## Request for Class II Permissive Change(C2PC)

FCC ID: R5FXM925AYY

**This is a C2PC application for which the previous grant was issued on 2018-05-11.**

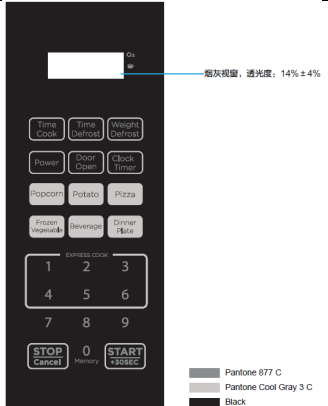
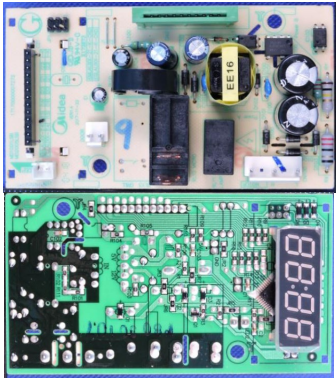
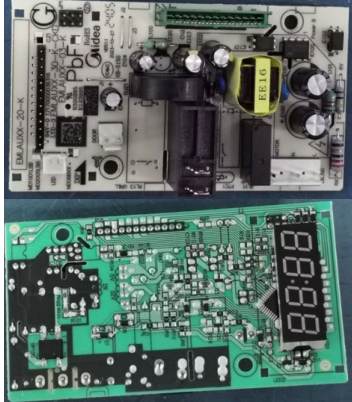
No.:	Original	New	Difference(s)
1			Keypad: Updated front keypad to accommodate child lock function (Child resistant oven door function).
2			Mother board: Modified the peripheral circuit (non-RF circuit) and some individual components and PCB layout. The magnetron and other circuit are exactly same as before.
3	Not Applicable		The new one adds a solenoid valve locking mechanism, the original is not.
